AMENDMENT OF SOLICITATION/MODIFICATION OF CONTRACT				1. CONTRACT ID CODE	PAGE 1 OF 3 PAGES
2. AMENDMENT/MODIFICATION NO. AMENDMENT NO. 0004		3. EFFECTIVE DATE 07/17/09	4. REQUISITION/PURCHASE REQ. NO.	5. PROJECT NO. (If applicable) 09-0232	
6. ISSUED BY CODE		CODE mks	7. ADMINISTERED BY (If other than Item 6) CODE See Item 6		
6. ISSUED BY Officer in Charge of Construction MCI-East 1005 Michael Road Camp Lejeune, NC 28547-2521					
8. NAME AND ADDRESS OF CONTRACTOR (No., street, county, State and ZIP Code)				(X)	9A. AMENDMENT OF SOLICITATION NO. N40085-09-R-0232
				X	9B. DATED (SEE ITEM 11) 07/06/09
					10A. MODIFICATION OF CONTRACT/ORDER NO.
					10B. DATED (SEE ITEM 11)
CODE		FACILITY CODE

09-0232, Office Improvements, Building 1

REVISED	A-1	DEPARTMENT OF THE NAVY NAVAL FACILITIES ENGINEERING COMMAND	
		MARINE CORPS BASE CAMP LEJEUNE, NORTH CAROLINA	
OFFICE IMPROVEMENTS		C/O'S OFFICE	
BLDG. 1		BLDG. 1	
DES. AL SAWLIE	DATE 7/17/09	SIZE CODE IDENT. NO. F 80091	NAVFAC DRAWING NO. 600004171
DR. C. BELL	DATE 7/17/09	CONSTR. CONTR. NO. N4005-04-B-0292	SHEET 1 OF 1
CHK. AL SAWLIE	DATE 7/17/09	SCALE: NOTED SPEC. 05-09-0292	
SUBMITTED BY: AL SAWLIE	DATE 7/17/09	SHEET 1 OF 1	
DESIGN

PART PLAN BLDG. 1

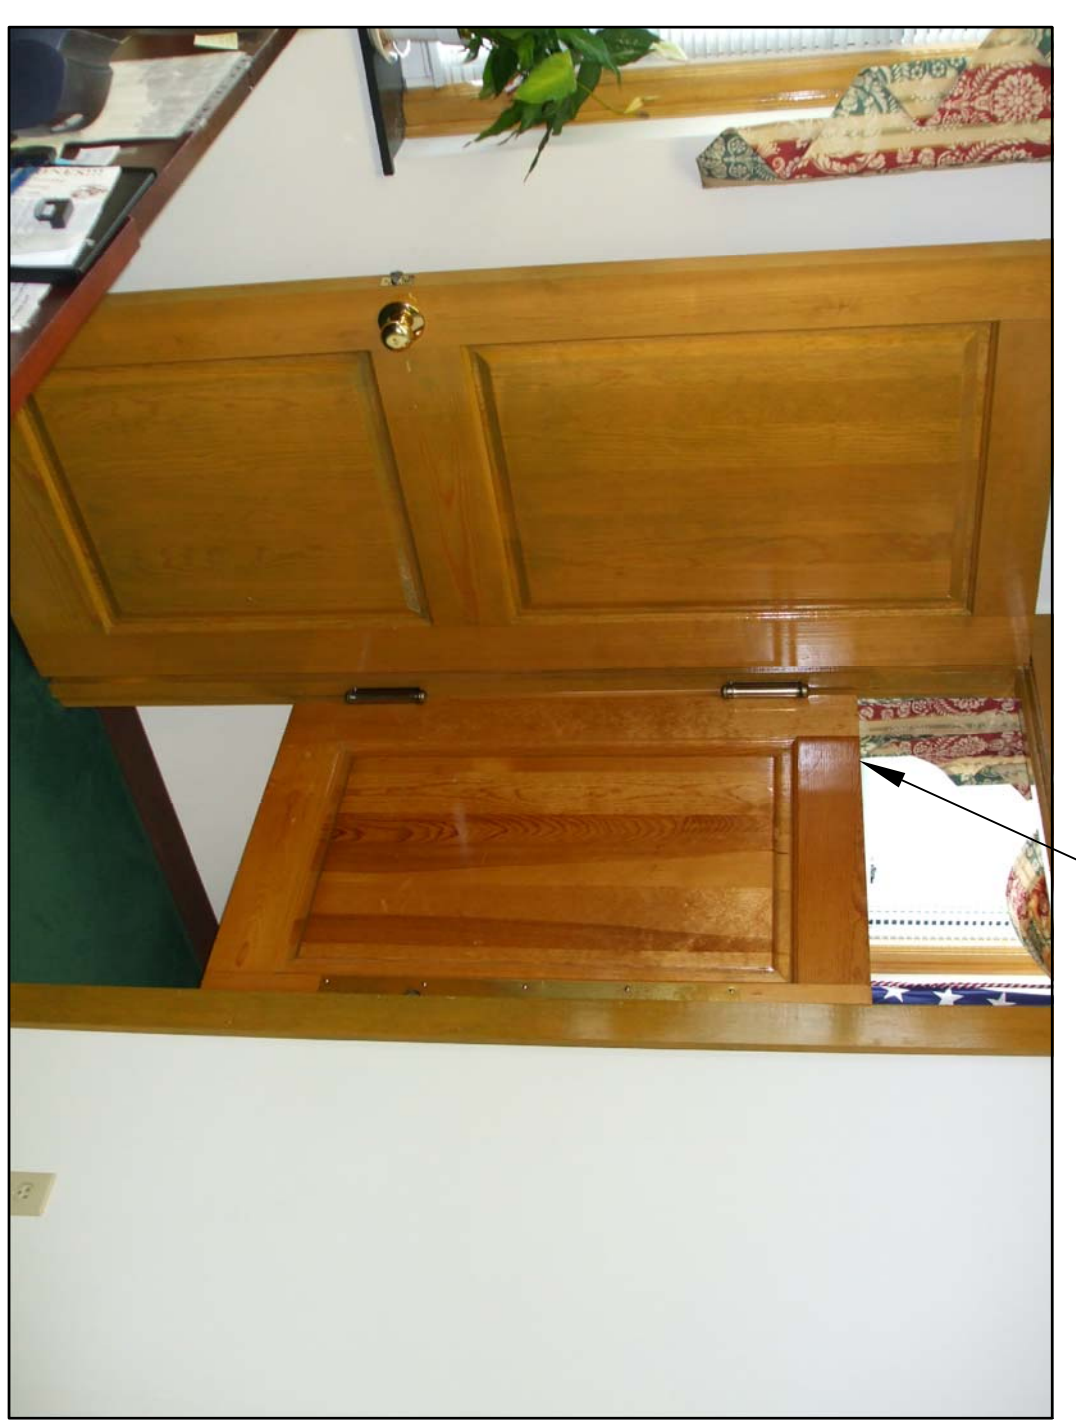
1. Delete the original drawing and replace with the attached REVISED Drawing.

2. Question: The existing wood doors are a historical feature of this building and can only be replaced by an exact replica. No metal door can be used. Door 1 requires a steel door, which should be rejected by the Historical Commission. We are unable to find a sound retardant wood door that will match. Please provide a mfr. that can provide the required new door (comment also applies to Doors 2, 3 & 4).

2. Answer: Question no longer relevant. New doors have been deleted from SOW.
3. Question: The notes require the reuse of existing wood door frames. The wall thickness at Doors 1, 3 & 4 will be increased at least 2-5/8" for the metal furring and GWB. Are we to provide an extension to the existing door casing or replace the casing with a wider wood piece?

3. Answer: Replace the Casing with a wider wood piece.
4. Question: There are several communications/ computer wall outlets in way of the new work. These features are usually undercontract to the user and can not be serviced by the contractor's forces. Please confirm the owner will have these wall outlets relocated to the face of the new painted GWB.

4. Answer: The Contractor is responsible for relocating all electrical and communication outlets and switch boxes to make flush with new wall surface.
5. Question: During a visit to the jobsite yesterday the owner advised they will remove and replace furniture and wall hanging in way of the new work at least 4 ' away from the wall. Please confirm this is the contracts intent.

5. Answer: Contractor is responsible for moving furniture and wall hanging articles at least four feet away from wall for new work.

REINSTALL CAFE DOOR AFTER EXISTING DOOR RE-INSTALLATION

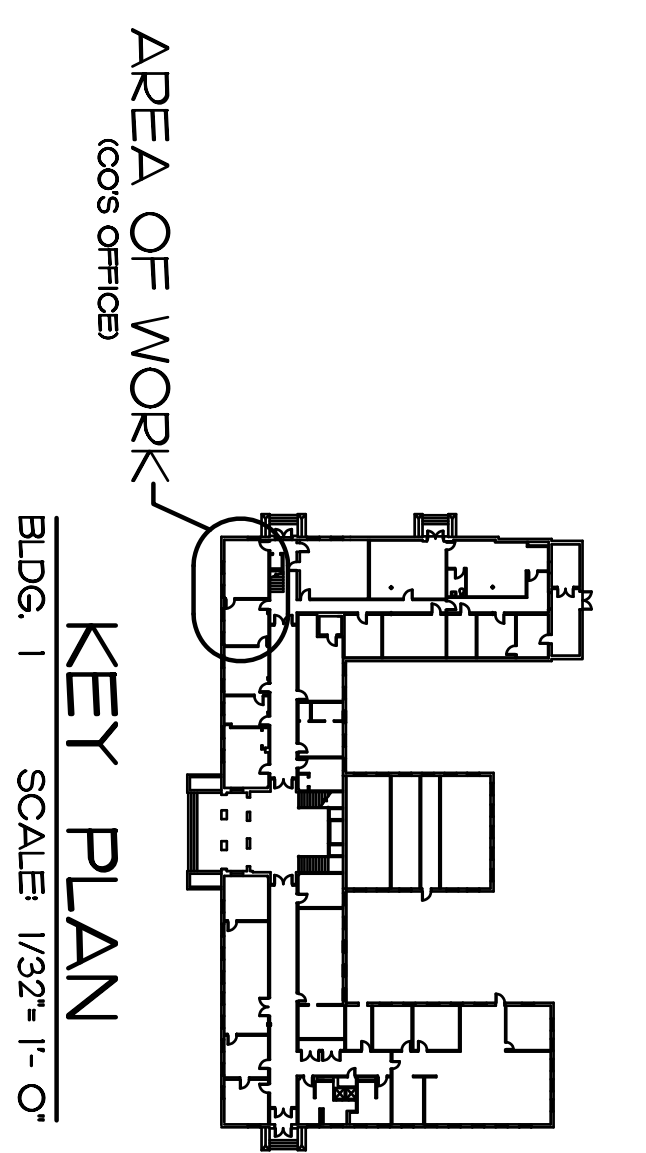
11. REMOVE AND REINSTALL EXISTING CAFE STYLE DOOR ON NEW OR EXISTING FRAME AS NEEDED FOR RE-INSTALLATION OF EXISTING DOOR. SEE PHOTO.
